Work Order ID 105848

Item Name: Aft Crosstube - High

DART SERVICE INSTRUCTION

DRAWING NO. D212-664-241	TITLE CROSSTUBE ASS'Y (205/212 HI AFT)	REV. D	DART AEROSPACE LTD ENGINEERING ORDER		D.E.O. NO. D212-664-241-D-2	SHEET NO. SHEET 1 OF 1	SCALE NTS
DRAWN 97	CHECKED ASS	MFG. APPR. 8	APPROVED MP		DE APPR. H		
DATE 11.07.15	DATE 11.07.20	DATE 11.07.21	DATE 11/27/21		DATE 11-07-21

FIGURE 1: SUPPORT INSTALLATION

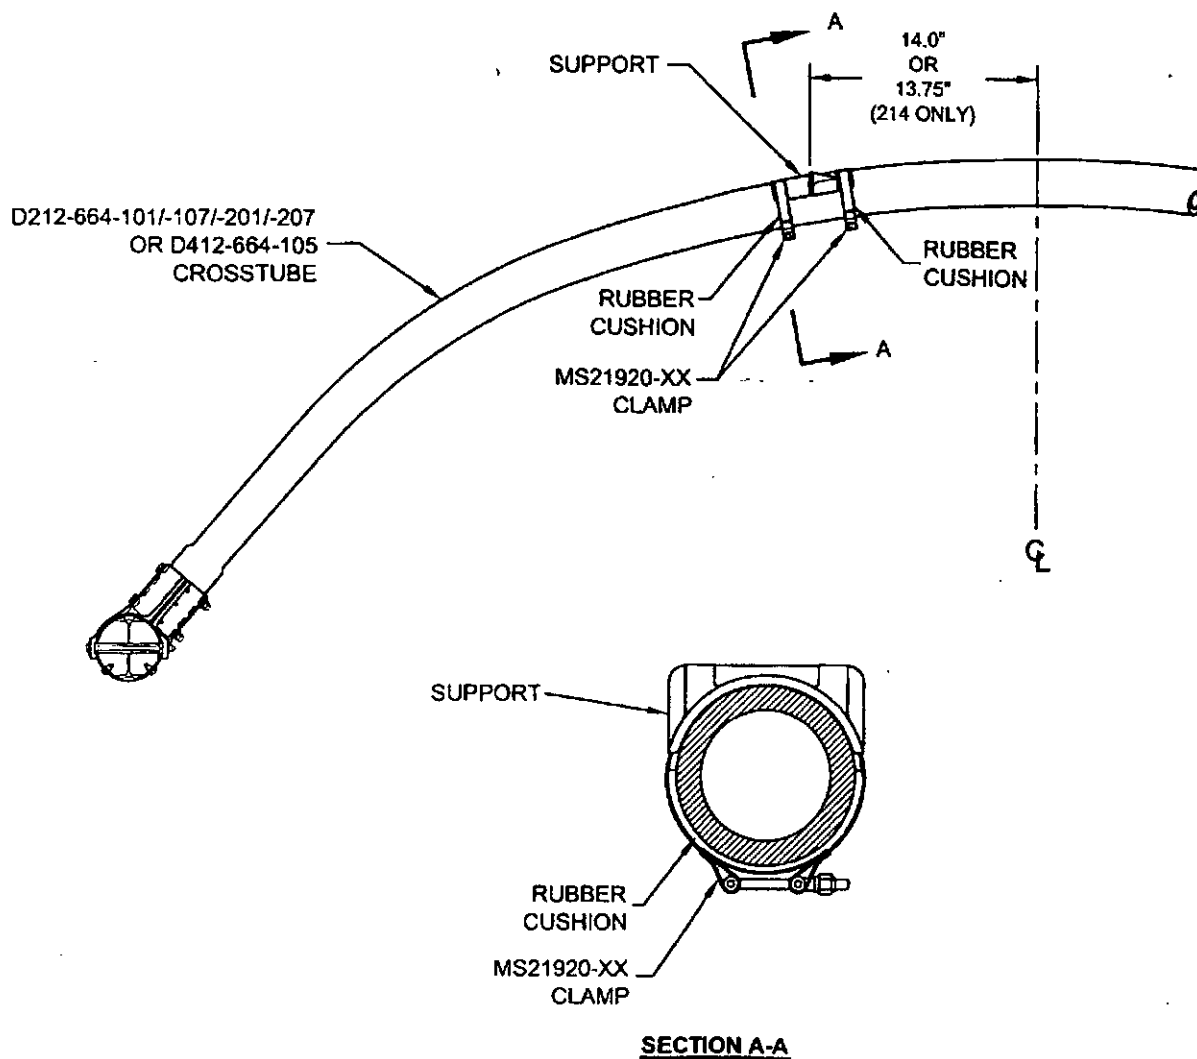
The supports on the following crosstubes are now installed using Proseal instead of Magnobond:

For the crosstubes listed above, section 32.4 of ICA-D212-664 is amended as follows. Use Figure 1 of this service instruction and Figures 32-2 to 32-9 of ICA-D212-664 for further reference. For crosstubes of an earlier change number, it is recommended that if the supports are removed, the supports should be reinstalled using the procedure listed below.

- 32.4.5 Apply a 0.04" to 0.07" thick layer of Proseal 890 Class B or AMS-S-8802 Class B sealant underneath applicable support and install support as shown in Figure 1 of this service instruction.

- 32.4.6 Install the clamps opposite to crosstube support as shown in section A-A of Figure 1. Install rubber cushions underneath each clamp around the bottom circumference of the crosstube up to the crosstube centerline. Torque clamps 80-100 in·lb (9.0-11.3 Nm). It is acceptable to use smaller or larger sized MS21920-XX clamps than those listed in ICA-D212-664, ensure that after torquing the clamps per this instruction, the nuts are in safety but not bottomed out.

- 32.4.1 Locate the area on the crosstube for installation of support (see Figure 1 of this service instruction). For D212-664-101/-107/-201/-207 and D412-664-105 crosstubes, the outward face of the support tabs should be 14.0" (355mm) from the crosstube center for 204/205/210/412/UH-1 aircraft. For installation on 214B/B-1 aircraft, the outward face of the support tabs should be 13.75" (349mm). Ensure paint finish of crosstube is intact; touch up as required per Chapter 5 (5.3.9) of ICA-D212-664.

- 32.4.2 If present, remove any paint/primer on bottom of supports. Abrade mating surfaces of support and crosstube with 400-grit sandpaper. Saturate a clean cloth with MEK or 4105S Wash'n'Wipe Degreaser or equivalent and wipe until there is no residue.

- 32.4.3 Ensure a layer of 3M Scotch-Weld 2216 B/A Epoxy Adhesive is on the bottom of the support. If required, either apply or touch-up support to have a 0.03" to 0.05" thick layer of adhesive over the entire mating surface. Allow supports to cure for 24 hours.

- 32.4.7 Prior to installing crosstube on aircraft, allow supports to cure for 72 hours and recheck torque on clamps.
